TECHNICAL BULLETIN

Camshaft Cover Oil Leaks – AJ16 Engine – Revised Bolt Torque Specification

12-60

MODEL 4.0L 1995-96 MY

ILLUSTRATION 1

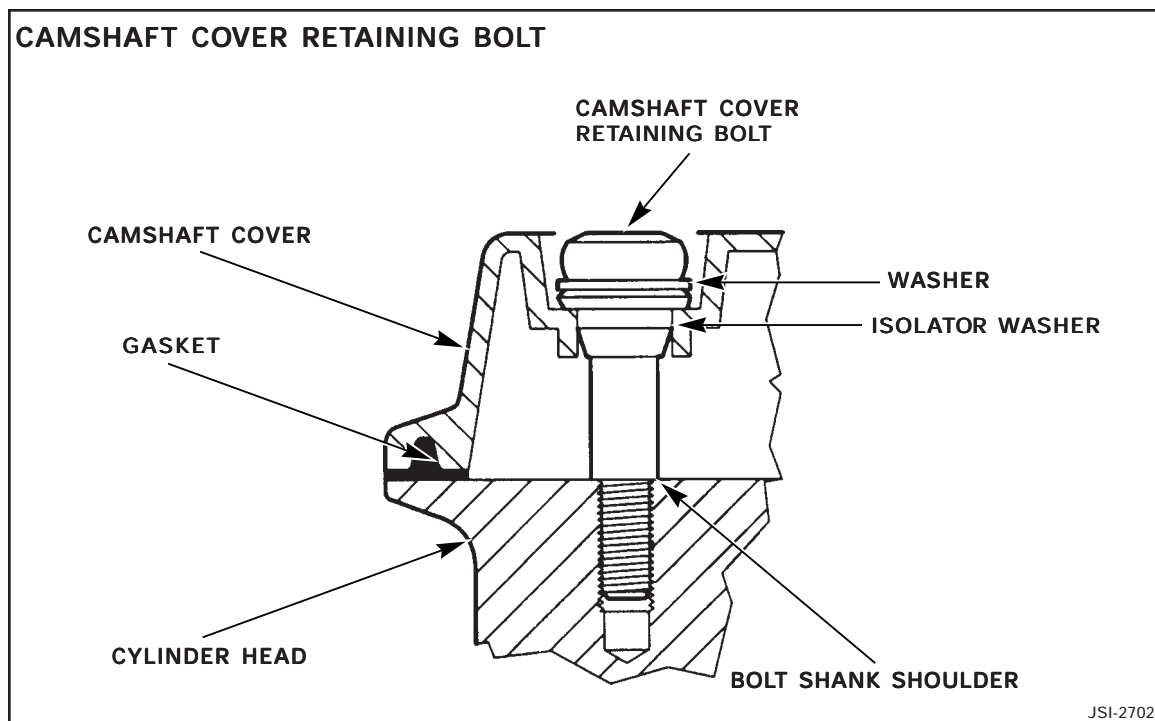
The torque specification for the camshaft cover retaining bolts has been revised beginning with VIN 767555 (Sedan Range) and VIN 225600 (XJS). The revised torque specification ensures that the shoulder on the shank of the bolt bottoms against the surface of the cylinder head (Illustration 1) to achieve even compression of the camshaft cover gasket and to reduce the incidence of oil leakage.

ILLUSTRATION 2

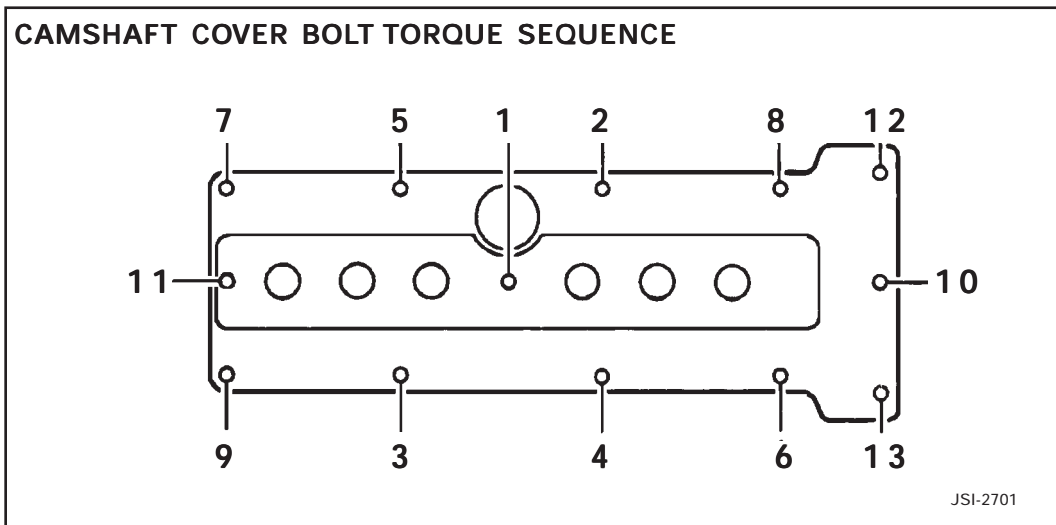
3. Install **new** seals in the spark plug wells.
4. Install a **new** camshaft cover gasket.
5. Install the camshaft cover and tighten the 13 retaining bolts "finger-tight."
6. Final tighten the retaining bolts in the sequence shown in Illustration 2
Torque the bolts to 5 lb. ft. (6.5 Nm).
7. Install new seals when reinstalling the "on-plug" ignition coils.
